Project
WATERLOO METRO QUARTER DEVELOPMENT

Sheet title
General Arrangement Plan
Level 01

Status	Revision
AFT D&C Builder	0
Sheet number	Revision
WMQ-BLD4-BSA-AR-DRG-DA101	0

Elevation South

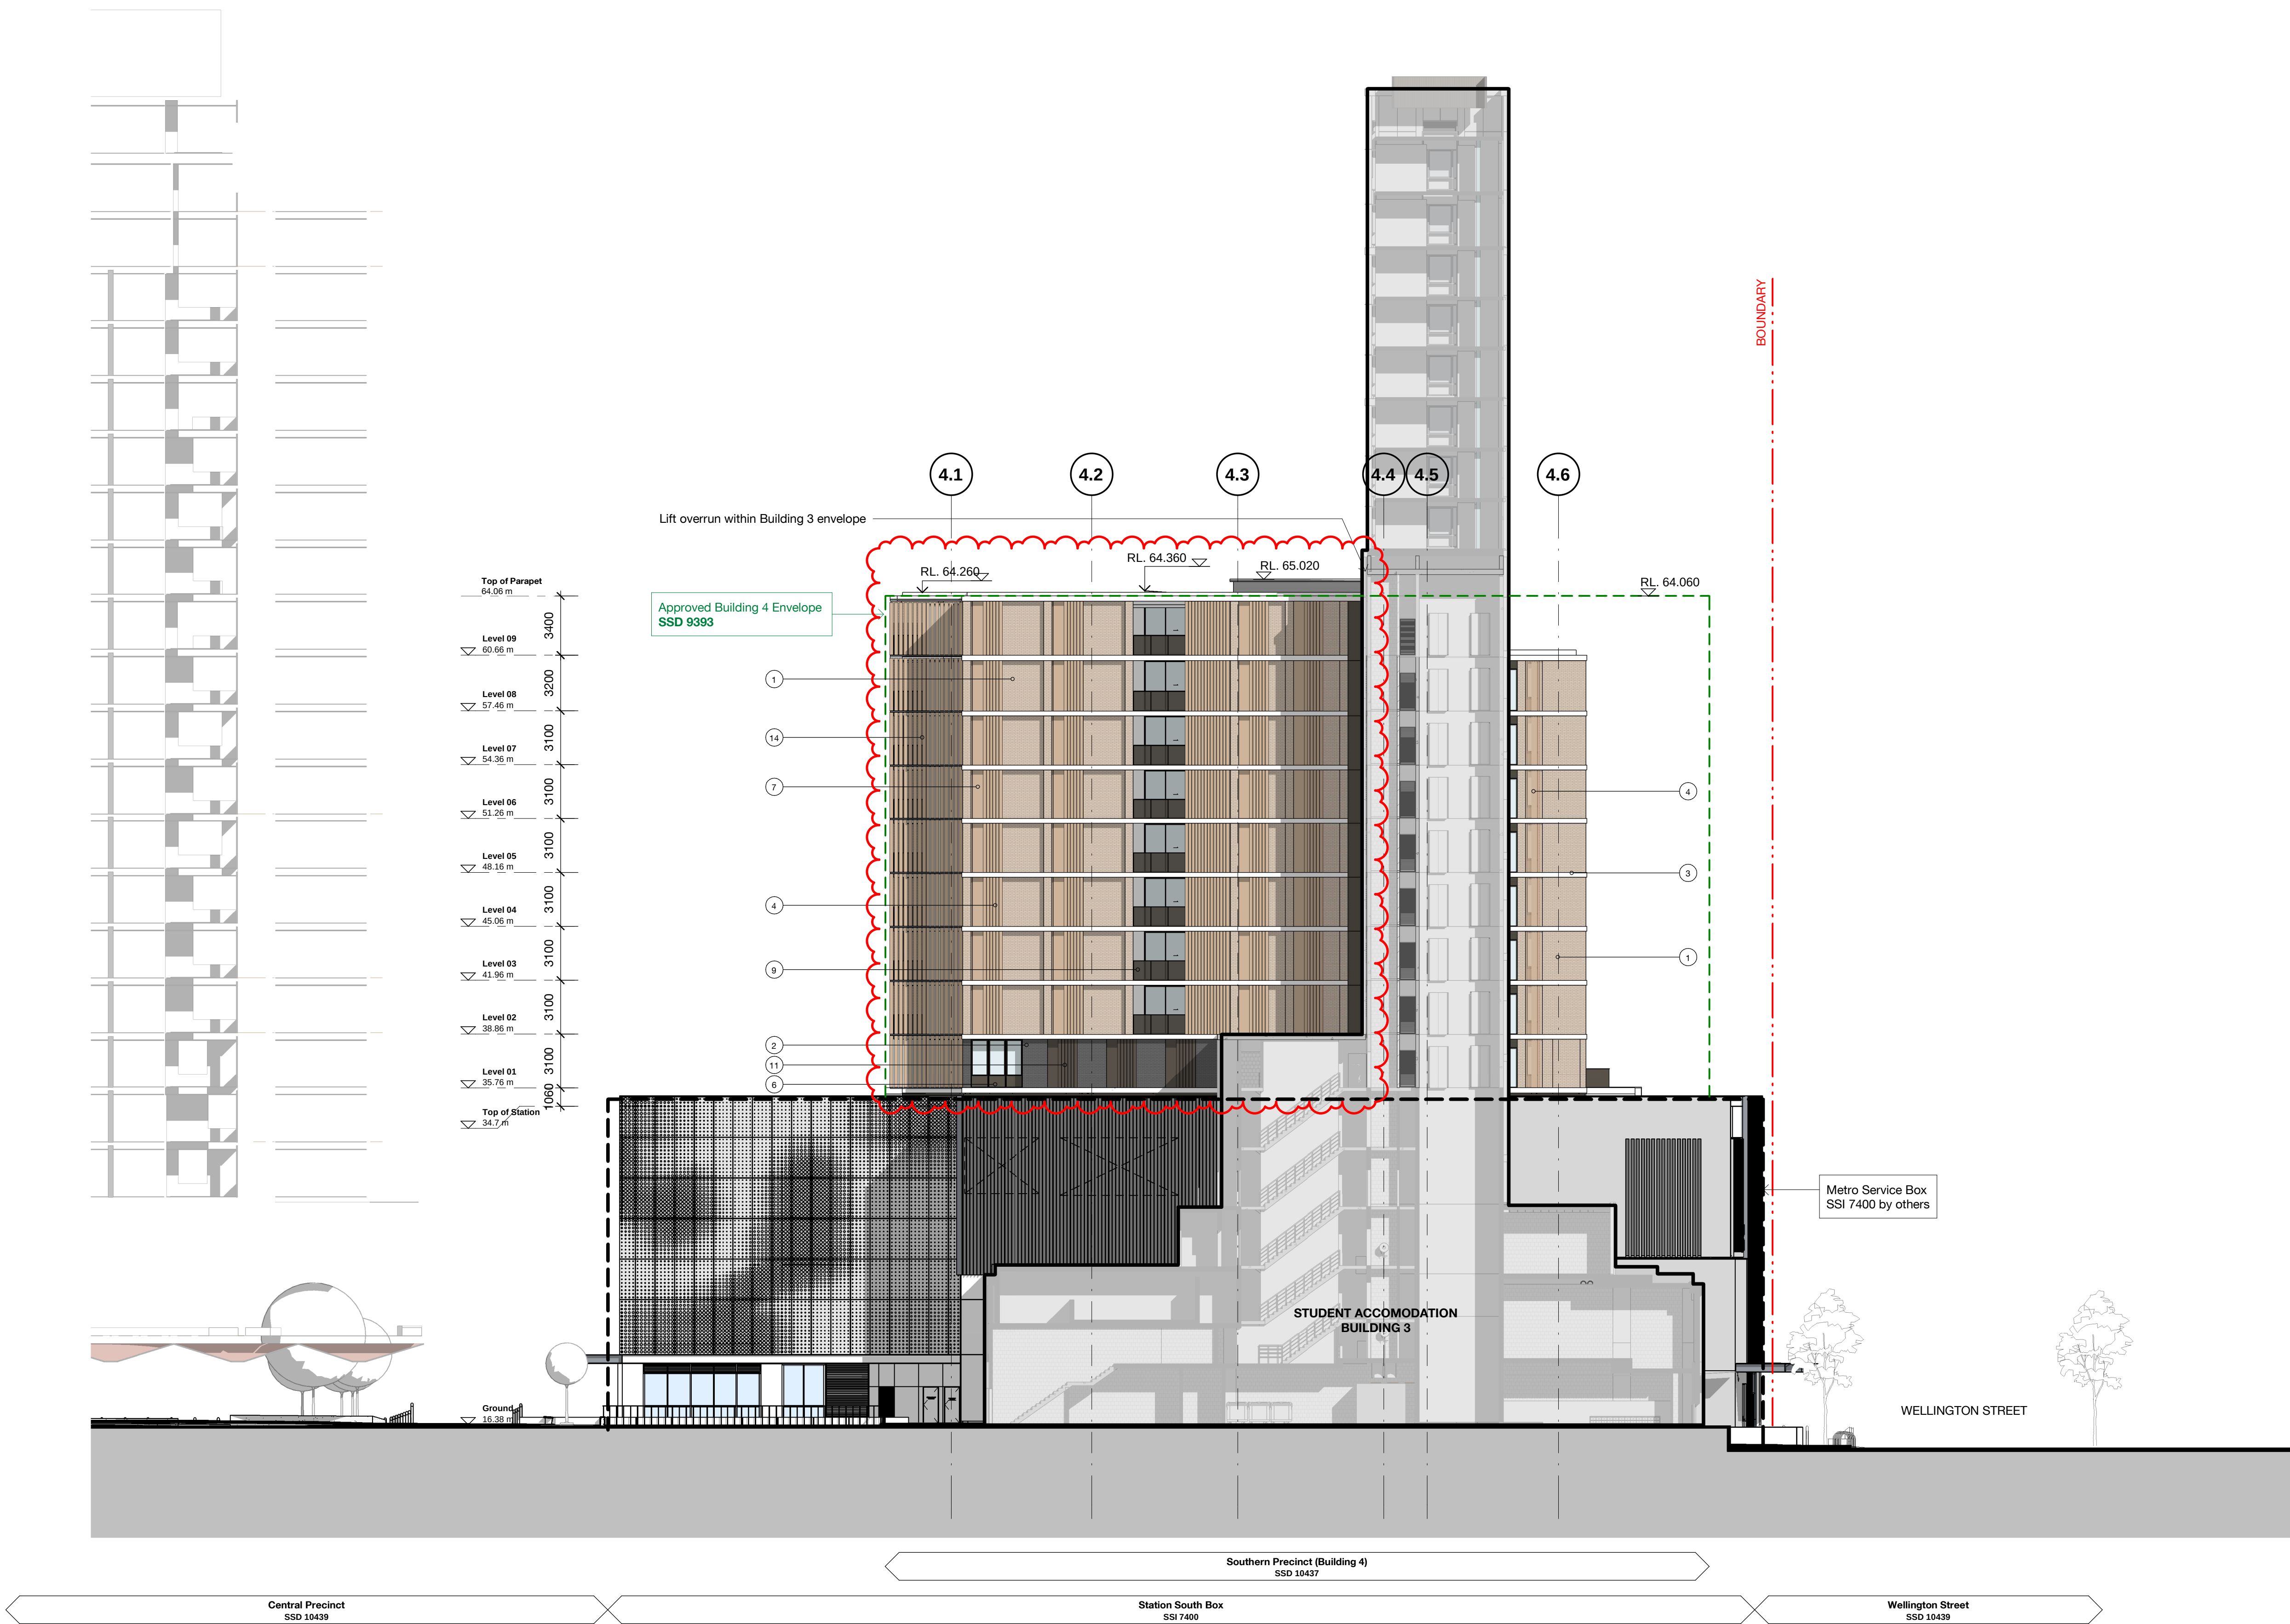
- Southern facade Level 9
- Roof plant enclosure
- Roof parapet
